**STATE OF HAWAII
DEPARTMENT OF TRANSPORTATION
HIGHWAYS DIVISION**

**ADDENDUM NO. 1
for
AKONI PULE HIGHWAY PAVEMENT PREVENTIVE MAINTENANCE
VICINITY OF MAHUKONA TO KOHALA RANCH
FEDERAL-AID PROJECT NO. STP-0270(019)**

ROUGH ROAD/UNEVEN LANES
FIGURE 8 - TRAFFIC CONTROL PLAN

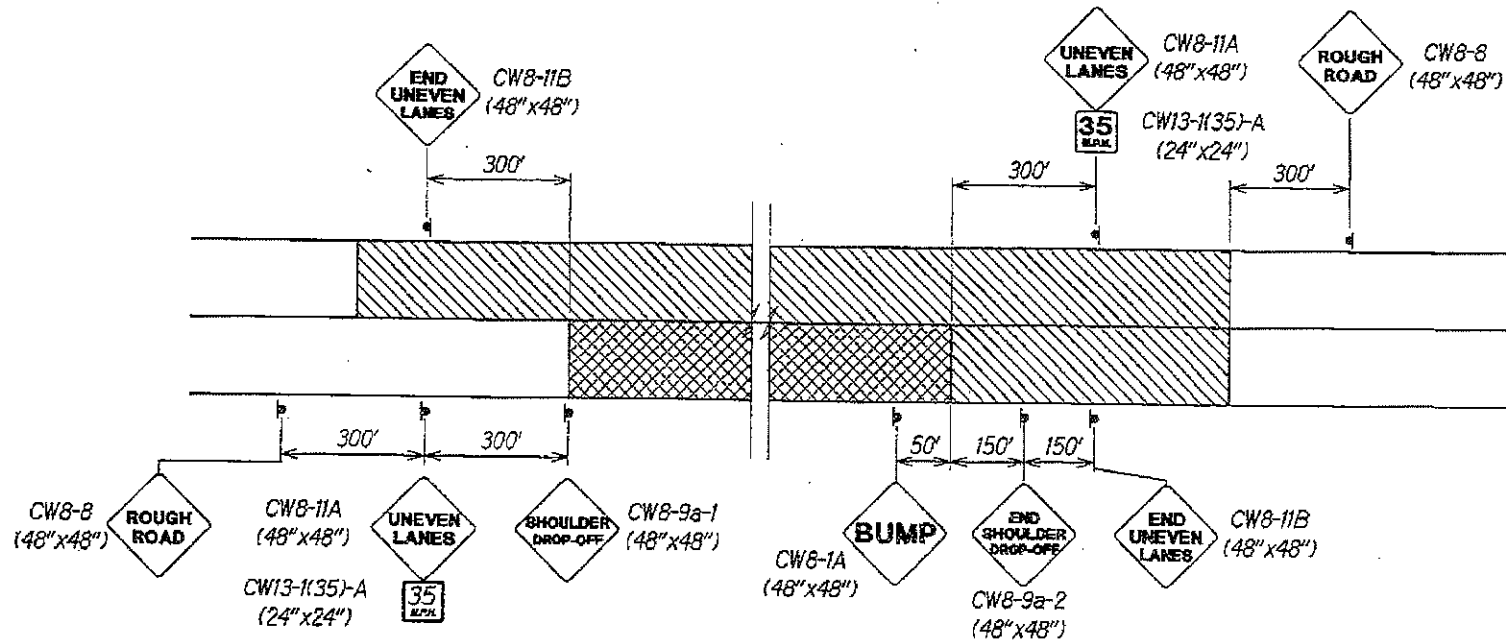
1. Amend section 645 – Traffic Control by adding “Rough Road / Uneven Lanes, Figure 8 – Traffic Control Plan”, sheet 645-1a dated 6/15/11.
